《混凝土結構作業守則 2013 年》

**Amendments to the Code of Practice for Structural Use of Concrete 2013 (2020 Edition)**  
**( February 2022 )**

**Amendments to the Code of Practice for Structural Use of Concrete 2013 (2020 Edition)**  
**( June 2023 )**

## **Amendments to the Code of Practice for Structural Use of Concrete 2013 (2020 Edition)**

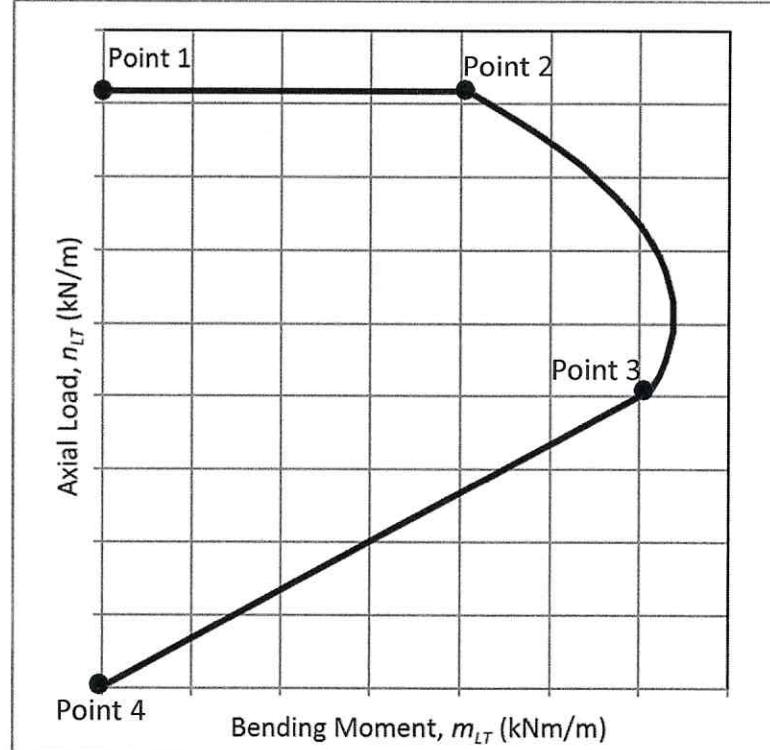
4. Clause 6.2.3 and Figure 6.18b	-	<p><b>6.2.3 Plain concrete linings</b></p> <p><b>6.2.3.1 General</b></p> <p>Plain concrete is suitable for use in structural members with high axial loads and relatively low bending moments. The following criteria can generally be applied to the use of plain concrete lining in tunnels or caverns:</p> <ul style="list-style-type: none"> <li>(a) the lining curvature is adequate to accommodate axial distribution of external loads;</li> <li>(b) the plain concrete lining is constructed in relatively good rock geology and is always in compression under all load combinations;</li> <li>(c) the effect of imperfection of the concrete lining has been considered by means of rigorous structural analysis of the plain concrete lining; and</li> </ul>

Item	Current version	Amendments
		<p>(d) an arch section can be formed by plain concrete in conjunction with a reinforced concrete invert provided the junction between the plain and reinforced concrete satisfies the design requirements specified in clause 6.2.3.2.</p> <p><b>6.2.3.2 Design of plain concrete lining</b></p> <p>(a) Maximum axial load for plain concrete lining</p> <p>The design ultimate capacity of axial load per unit length, <math>n_{LT}</math> and design maximum ultimate bending moment per unit length, <math>m_{LT}</math> (<math>=n_{LT} e_x</math>) shall be evaluated using the interaction curve as shown in Figure 6.18b.</p> <p>(i) The first section (Point 1 to Point 2) of the interaction curve as shown in Figure 6.18b, the highest axial force, is applicable when the eccentricity of the thrust force is less than or equal to 0.1h. The ultimate capacity is calculated using a rectangular stress block over the whole section;</p> <p>For <math>e_x \leq 0.1h</math></p> $n_{LT} \leq 0.32h f_{cu} \quad 6.63a$ <p>(ii) The second section (Point 2 to Point 3) of the interaction diagram is based on a rectangular stress block approach and is applicable for eccentricity between 0.1h and 0.3h. The stress block is acting over part of the section, and reduces as the eccentricity increases.</p> <p>For <math>0.1h &lt; e_x \leq 0.3h</math></p> $n_{LT} \leq 0.4 (h - 2e_x) f_{cu} \quad 6.63b$ <p>where:</p>

Item	Current version	Amendments
		<p><math>e_x</math> is the resultant eccentricity of load at right angles to the plan of the lining.</p> <p>(iii) Cracking restriction limits the use of the strength design method to a maximum eccentricity of <math>0.3h</math>. The third section (Point 3 to Point 4) of the interaction curve is a straight line down to the point <math>n_{LT} = 0</math>, <math>m_{LT} = 0</math>, as shown in Figure 6.18b.</p>  <p>The figure shows an interaction curve plotted on a grid. The vertical axis is labeled 'Axial Load, <math>n_{LT}</math> (kN/m)' and the horizontal axis is labeled 'Bending Moment, <math>m_{LT}</math> (kNm/m)'. A horizontal line segment connects 'Point 1' (at the origin) and 'Point 2'. A vertical line segment connects 'Point 4' (at the bottom left) and 'Point 3'. A curved line segment connects Point 2 and Point 3. The curve is concave down, representing the interaction between axial load and bending moment. The region to the left of the curve is shaded.</p> <p>Figure 6.18b – Interaction Curve for Design of Plain Concrete Lining</p>

Item	Current version	Amendments
		 <p>Key</p> <p>X length of the mechanical coupler, in mm</p> <p>Y permanent elongation after loading to <math>0.6f_y</math>, in mm</p> <p>Figure 3.9a – Maximum allowable permanent elongation for type 1 mechanical couplers</p>

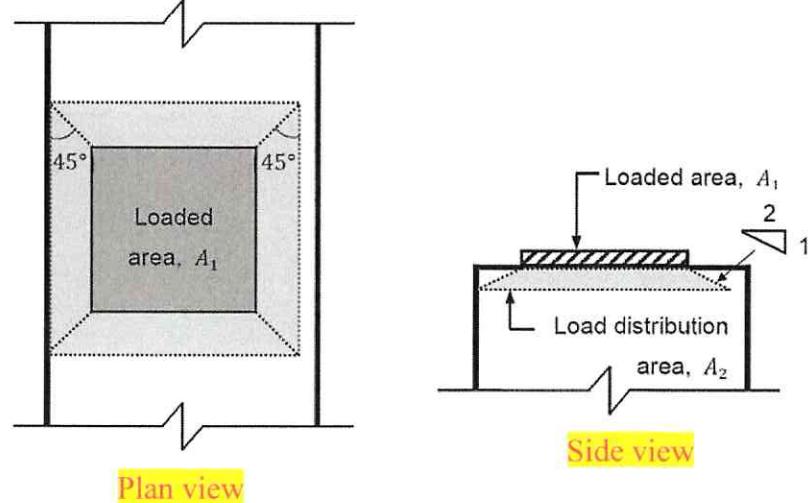
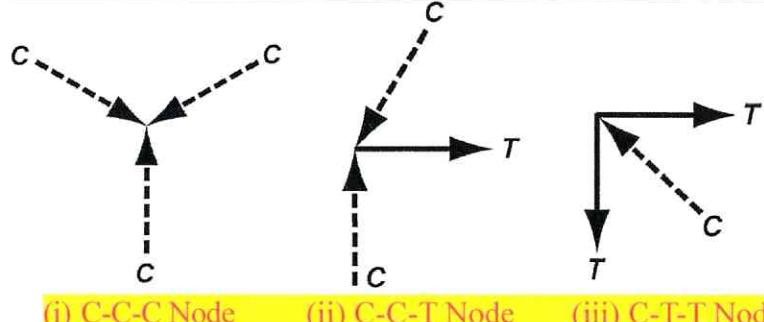
6. Clause 3.2.8.3 <sup>1</sup>	<p>3.2.8.3 Performance of type 1 mechanical couplers</p> <p>Type 1 mechanical coupler satisfying the following criteria may be used as an alternative to tension or compression laps:</p> <p>(a) when a representative gauge length assembly comprising reinforcement of the diameter, grade and profile to be used, and a coupler of the precise type to be used, is tested in tension the permanent elongation after loading to <math>0.6f_y</math> should not exceed <math>0.1 \text{ mm}^1</math>; and .....</p>	<p>3.2.8.3 Performance of type 1 mechanical couplers</p> <p>Type 1 mechanical coupler satisfying the following criteria may be used as an alternative to tension or compression laps:</p> <p>(a) when a representative gauge length assembly comprising reinforcement of the diameter, grade and profile to be used, and a coupler of the precise type to be used, is tested in tension the permanent elongation after loading to <math>0.6f_y</math> should not exceed <math>0.1 \text{ mm}^1</math>;</p> <p>(b) For couplers longer than 100 mm, the permanent elongation greater than <math>0.1 \text{ mm}</math> may be accepted as per Figure 3.9a subject to crack width control requirements in clauses 7.2.1, 9.4.1 and 12.3.4; and</p> <p>(c) the coupler bar.....</p>

<sup>1</sup> Addition of maximum allowable permanent elongation for mechanical couplers longer than 100 mm.

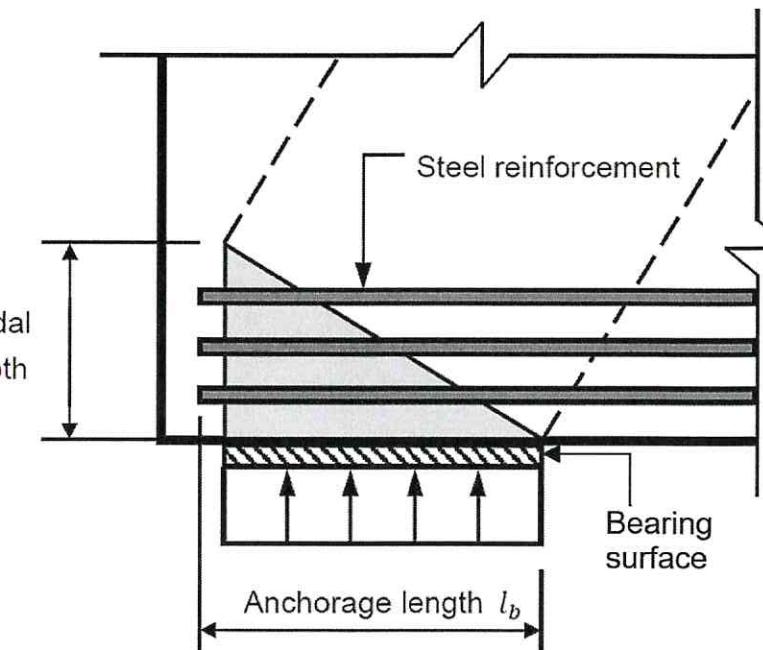
8. Clause 6.9 <sup>2</sup>		<p>6.9 STRUT-AND-TIE SYSTEM</p> <p>6.9.1 General</p> <p>Non-flexural components, e.g. locations near supports and concentrated loads, of reinforced concrete structures can be</p>

Item	Current version	Amendments
		<p>designed using strut-and-tie model. A strut-and-tie model is an idealized pin-jointed truss, comprising concrete compression struts, reinforcement tension ties, and concrete nodes.</p> <p><b>6.9.2 Modelling and analysis</b>  The angle between the axis of a strut and the axis of a tie (<math>\theta</math>) shall not be less than <math>25^\circ</math> nor exceed <math>60^\circ</math>. The boundary forces and the internal forces can be determined based on the static equilibrium and the truss analysis.</p> <p>The dimensions of nodes shall be determined based on the nodal condition shown in Figure 6.21 by using the static equilibrium corresponding to shear failure and plastic stress state (see Figure 6.22).</p>  <div data-bbox="1784 1071 2099 1229" style="border: 1px solid black; padding: 5px;"> <math display="block">F_s = \sqrt{F_1^2 + F_2^2}</math> <math display="block">l_s = l_1 \cos \theta + l_2 \sin \theta</math> <math display="block">\sigma_s = F_s / (l_s \times \text{breadth})</math> </div> <p><b>Figure 6.21 – Nodal condition</b></p>

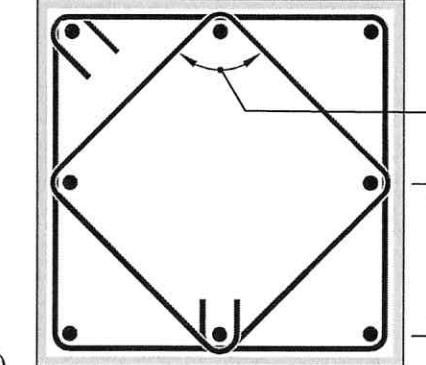
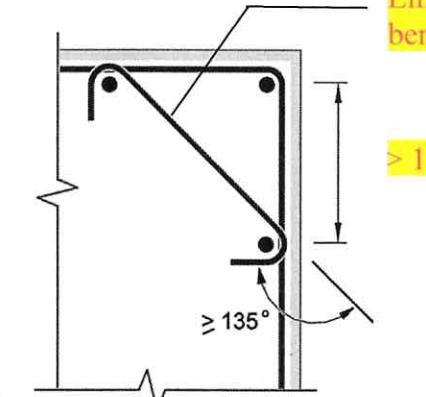
Item	Current version	Amendments
		 <p data-bbox="1304 557 2038 588">Figure 6.22 – Static equilibrium of a strut-and-tie model</p> <p data-bbox="1236 628 1432 660">6.9.3 Design</p> <p data-bbox="1236 668 1813 699">6.9.3.1 Design compressive strength of strut</p> <p data-bbox="1342 707 2105 771">Design compressive strength of concrete in strut <math>f_{cc}</math> should be calculated from:</p> $f_{cc} = 0.32m f_{cu}$ <p data-bbox="2009 815 2083 847">6.74</p> <p data-bbox="1342 890 1423 922">where</p> <p data-bbox="1371 929 2105 961"><math>m</math> is the confinement modification factor taken as</p> $\sqrt{\frac{A_2}{A_1}} \leq 2,$ <p data-bbox="1371 1041 1634 1072"><math>A_1</math> is loaded area,</p> <p data-bbox="1371 1080 1993 1112"><math>A_2</math> is load distribution area (see Figure 6.23).</p>

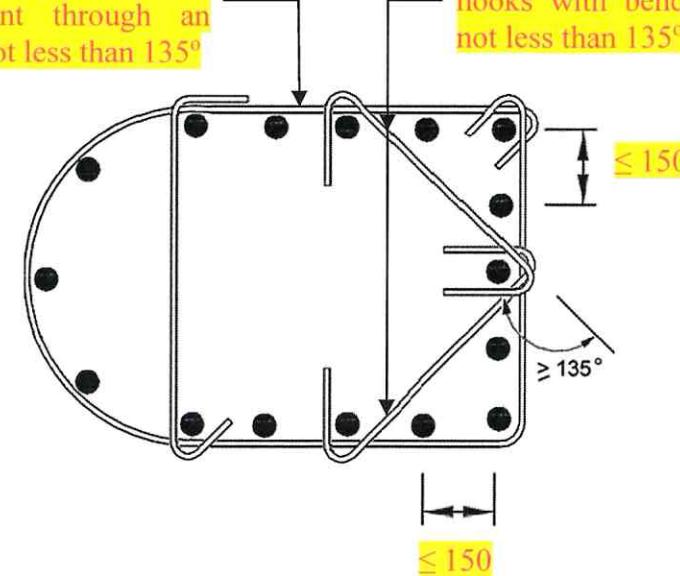
Item	Current version	Amendments
		 <p>Figure 6.23 – Load distribution area and loaded area for determining the confinement modification factor</p> <p>6.9.3.2 Design compressive strength of nodes Design compressive strength of concrete at a nodal zone <math>f_{ce}</math> should be calculated as follows:</p> <p><math>f_{ce} = 0.45m f_{cu}</math> for node bounded by struts, bearing areas or both (C-C-C Node) 6.75</p> <p><math>f_{ce} = 0.4m f_{cu}</math> for node anchoring one tie (C-C-T Node) 6.76</p> <p><math>f_{ce} = 0.32m f_{cu}</math> for node anchoring two or more tie (C-T-T Node) 6.77</p> <p>Classification of nodes is illustrated in Figure 6.24.</p>

Item	Current version	Amendments									
		 <p data-bbox="1320 514 2045 541"> <span data-bbox="1320 514 1506 541">(i) C-C-C Node</span> <span data-bbox="1544 514 1775 541">(ii) C-C-T Node</span> <span data-bbox="1813 514 2045 541">(iii) C-T-T Node</span> </p> <p data-bbox="1439 584 1865 620">Figure 6.24 Classification of nodes</p> <p data-bbox="1236 660 1836 695">6.9.3.3 Design compressive strength of bearing</p> <p data-bbox="1342 695 2090 768">Design ultimate bearing strength based on the weaker of the two bearing surfaces <math>f_{cb}</math> should be calculated as follows:</p>
